MATERIAL CHANGES:

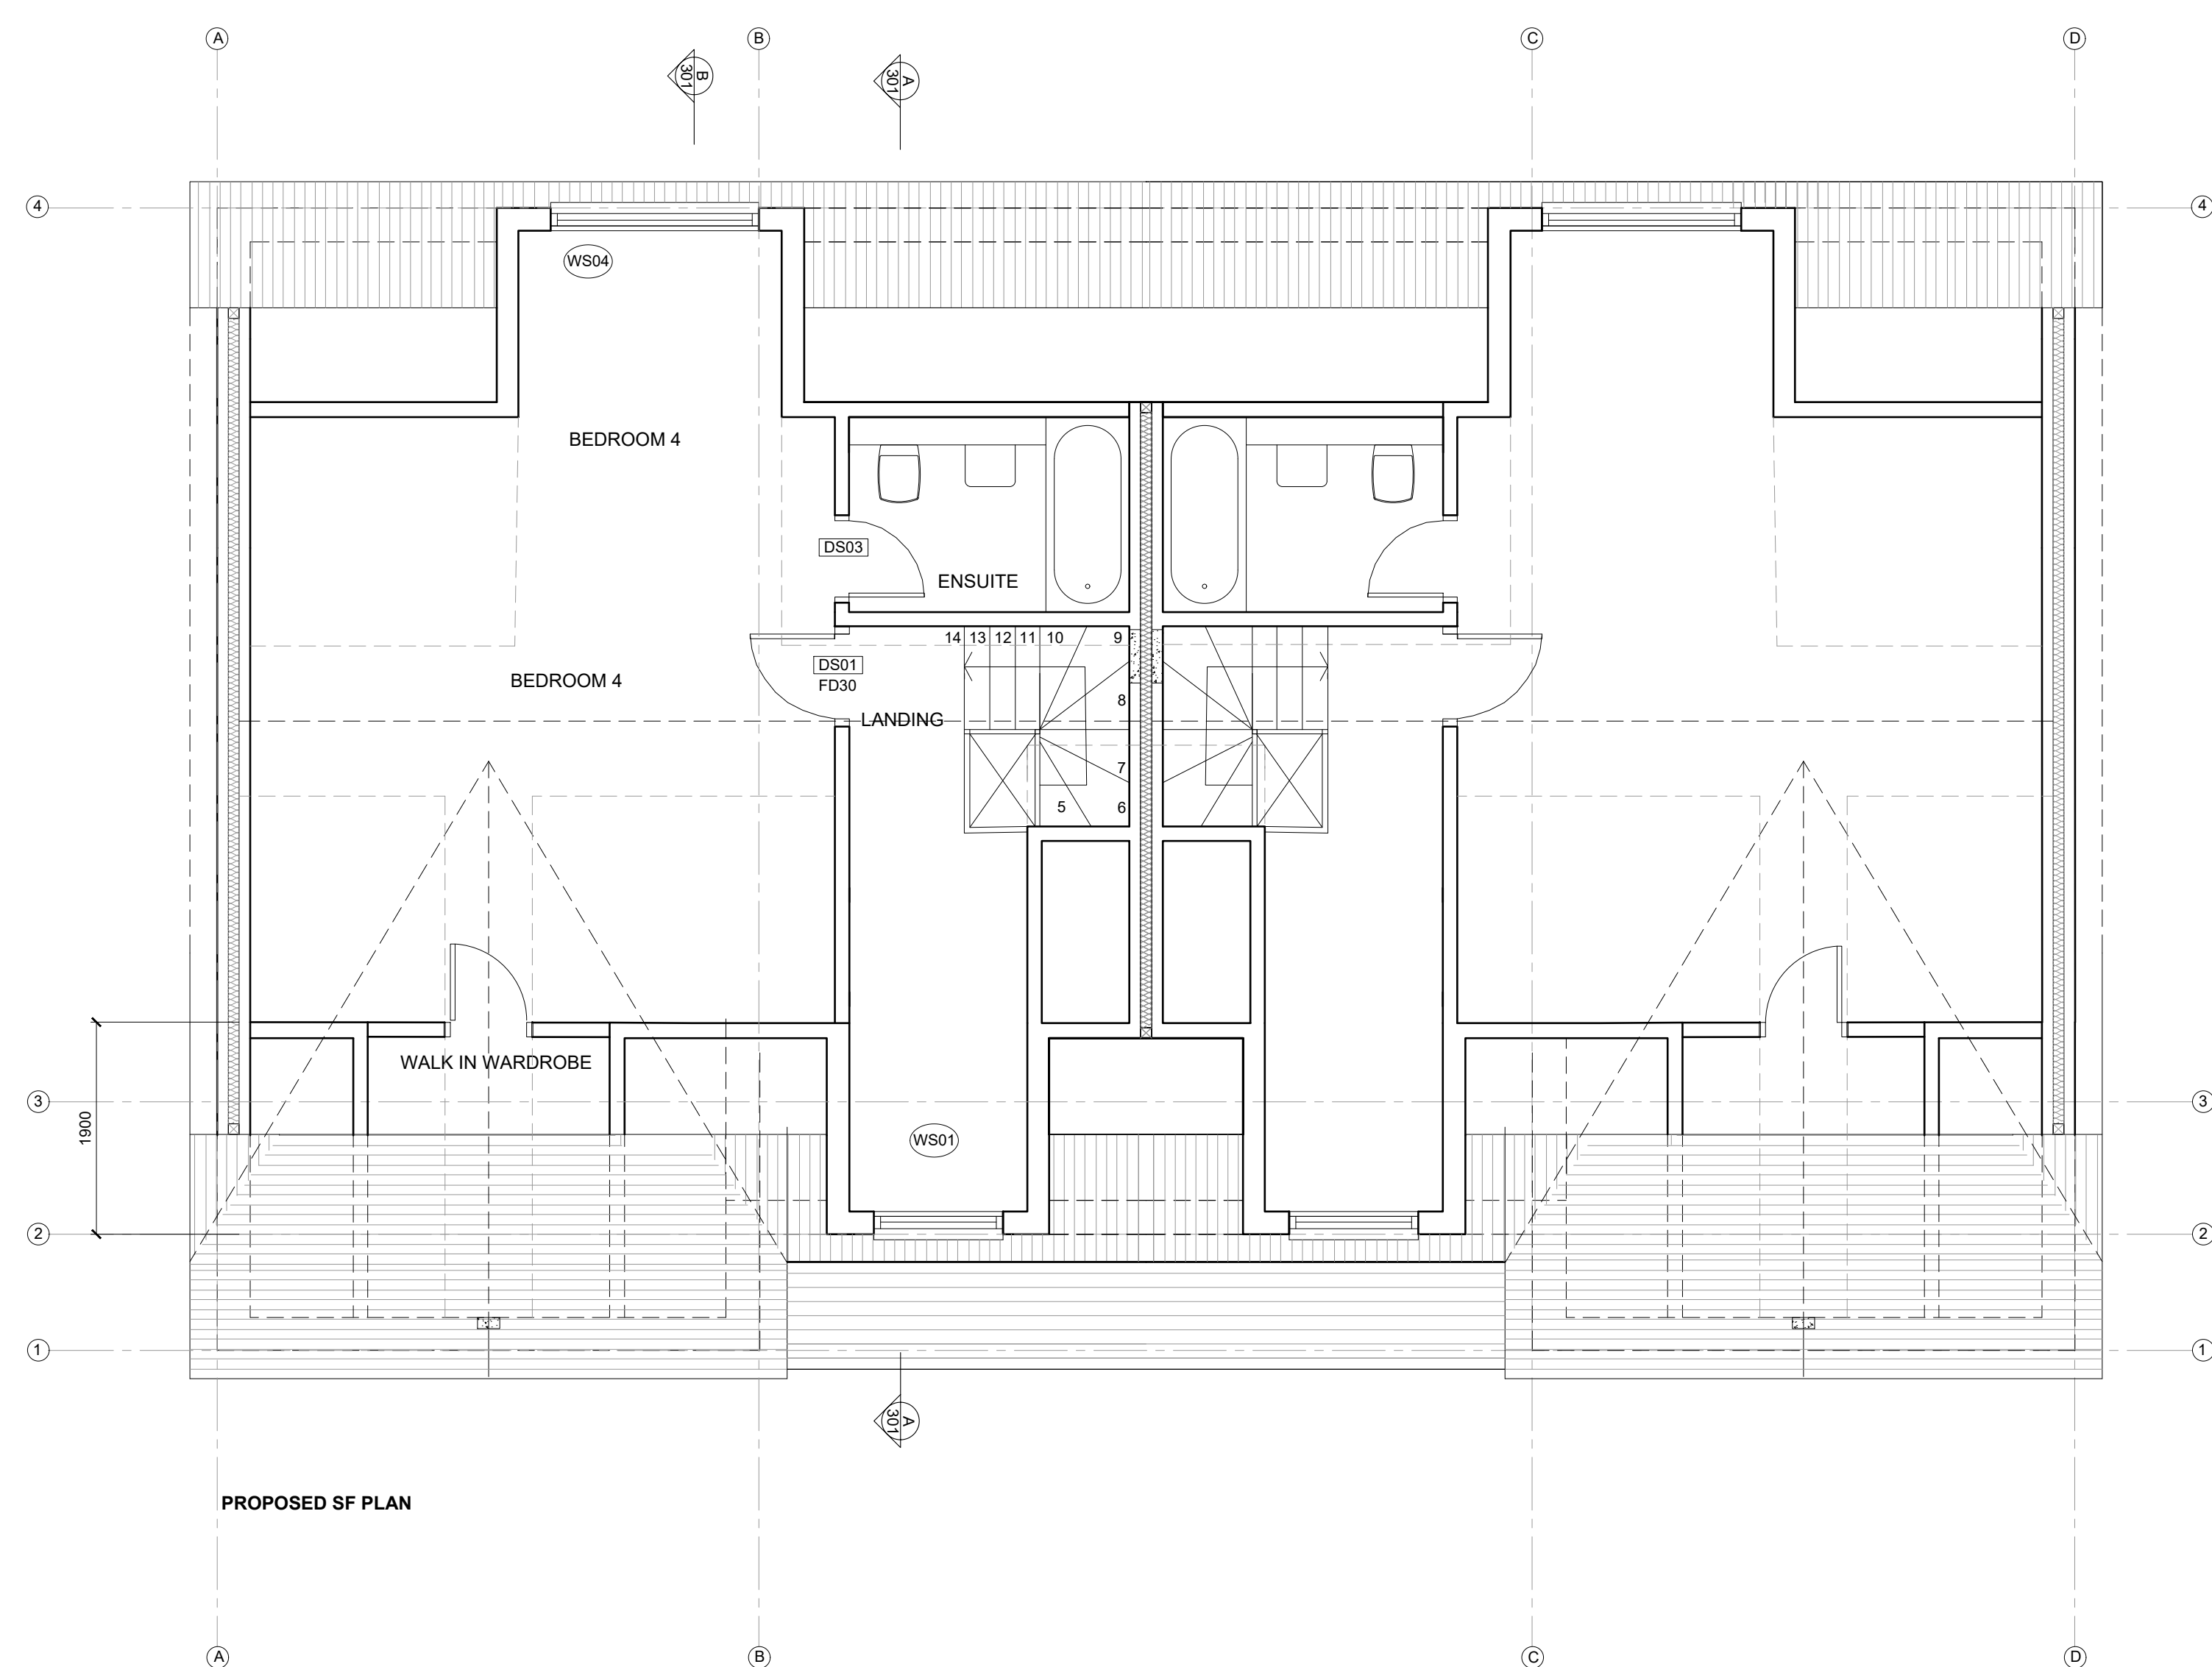
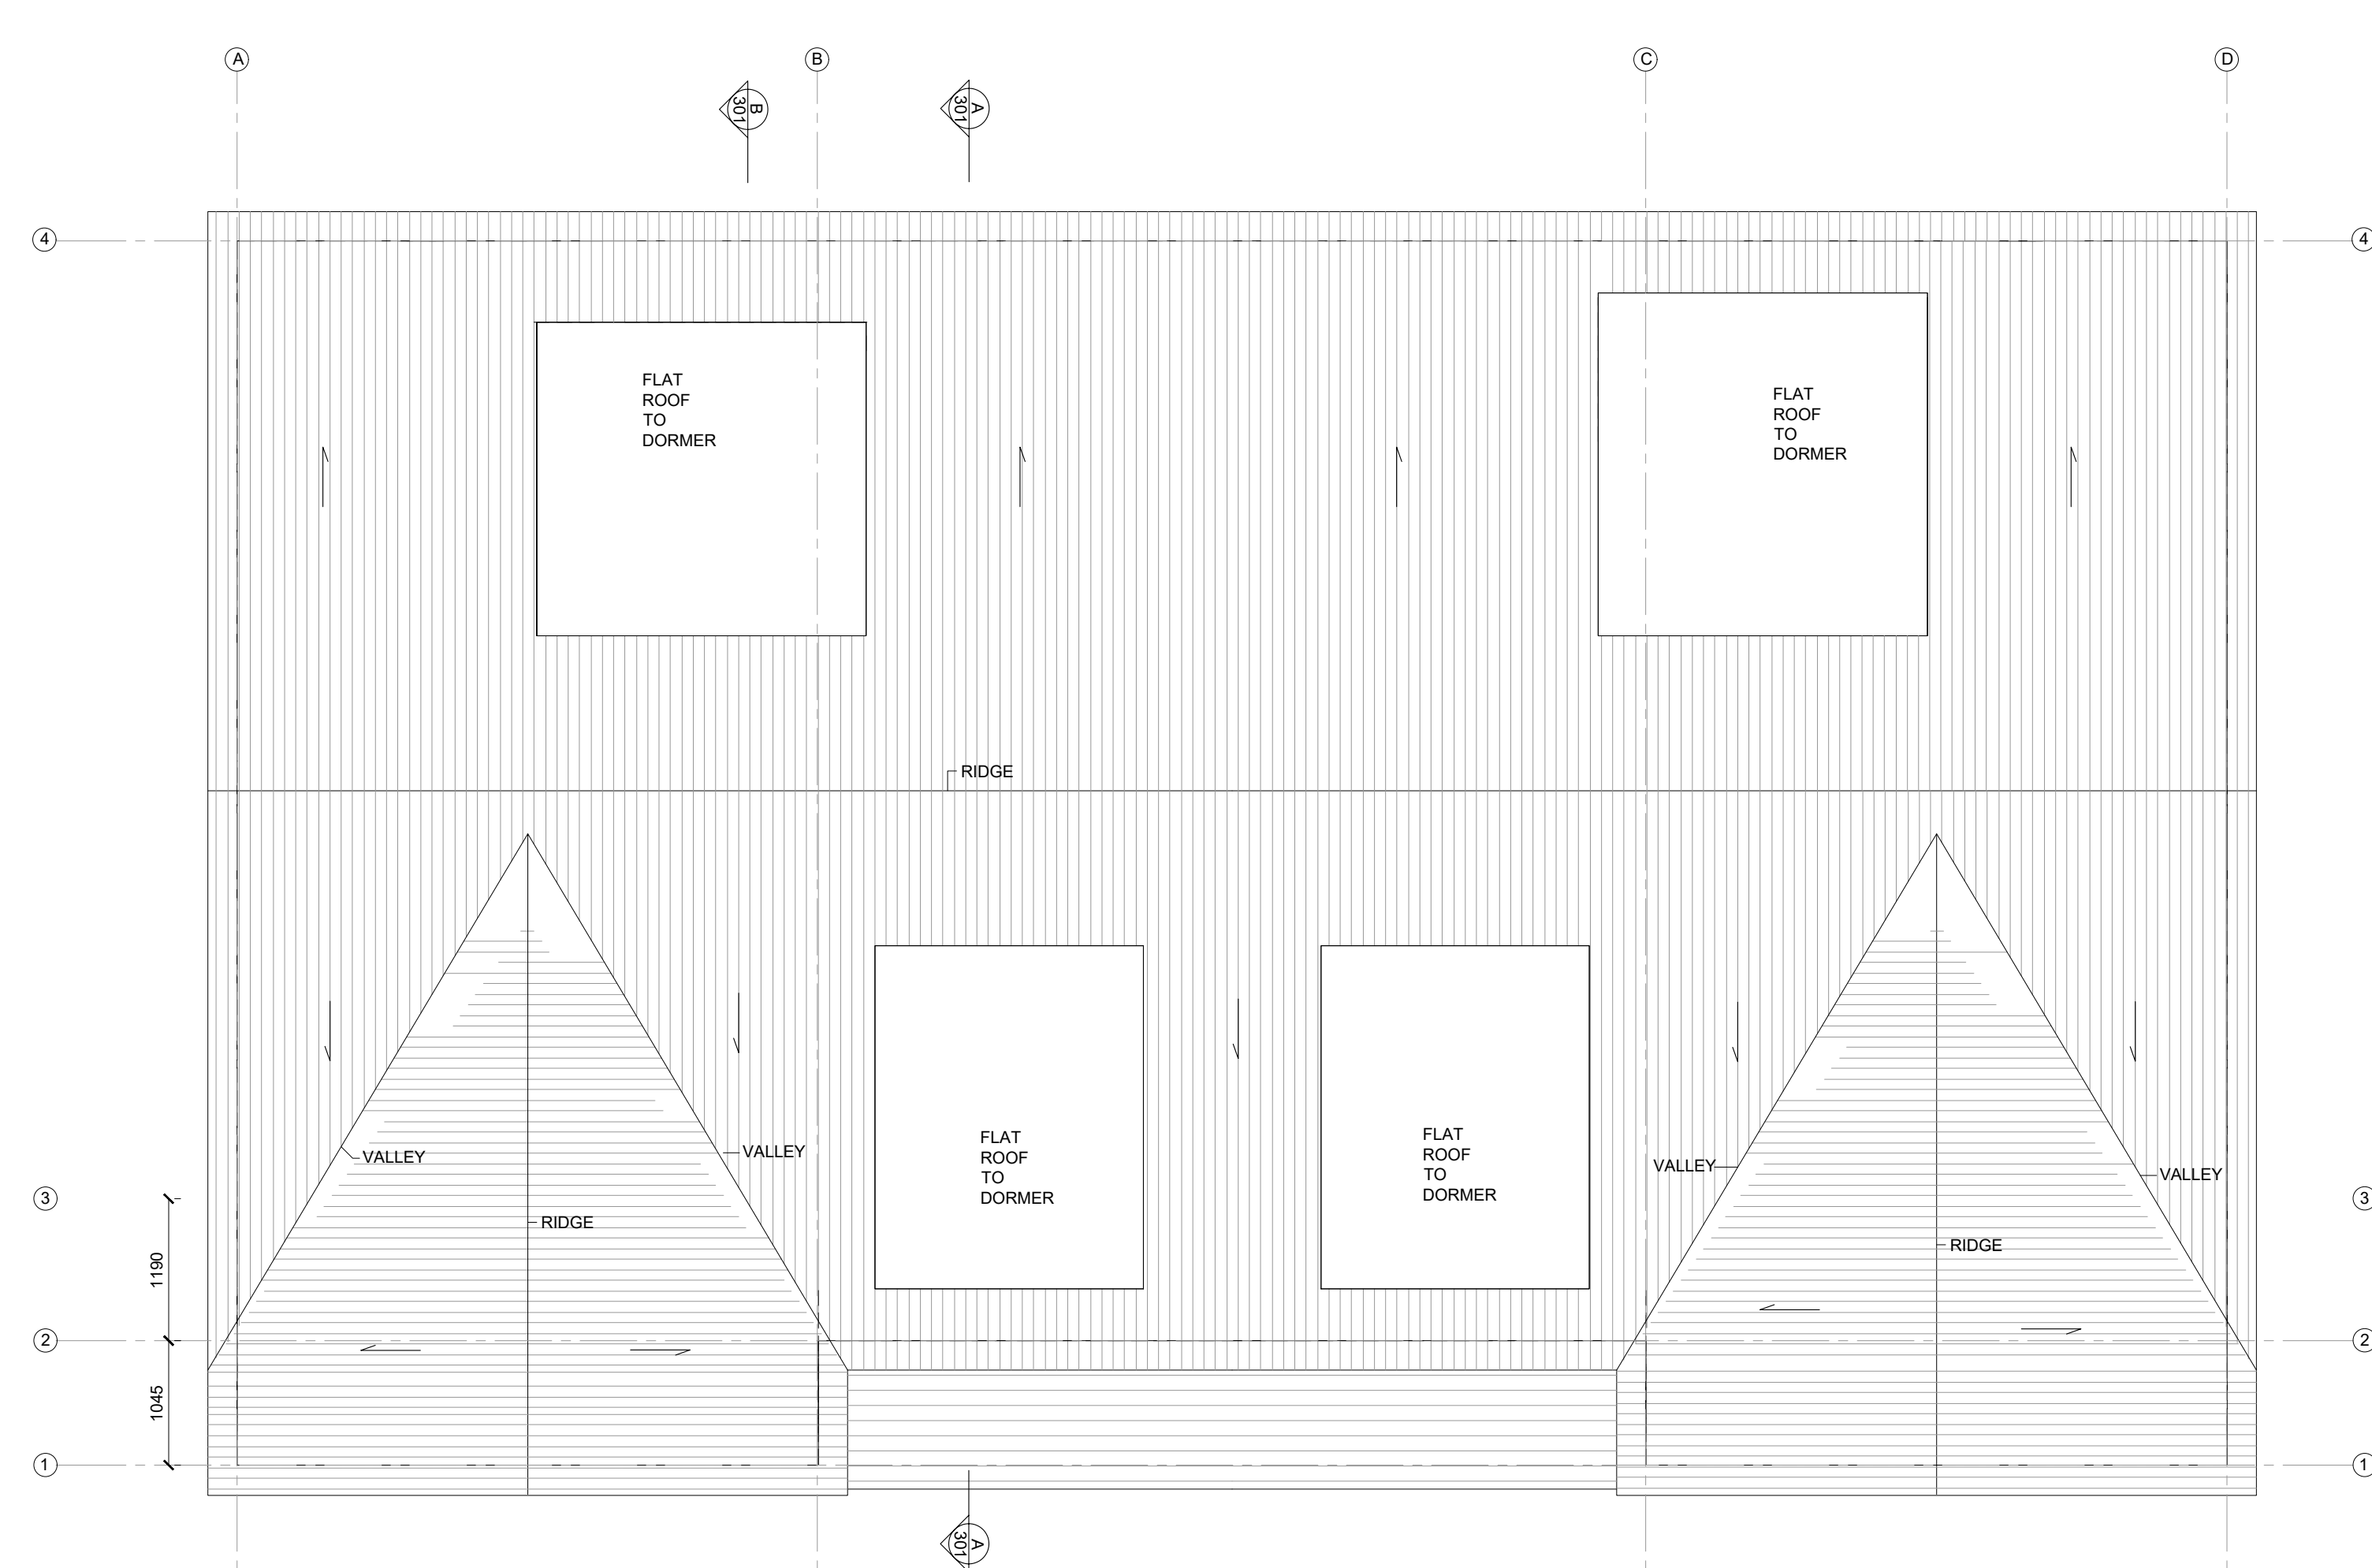
1. FRONT WALL BETWEEN TWO PROJECTING BAYS ON THE FIRST FLOOR HAS BEEN BROUGHT FORWARD AND THE ROOF ADJUSTED TO SUIT THE NEW SETTING OUT FOR THE WALL PLATE.
2. THE FLAT ROOF DORMERS TO THE REAR OF THE HOUSE HAVE BEEN ENLARGED (WIDENED)
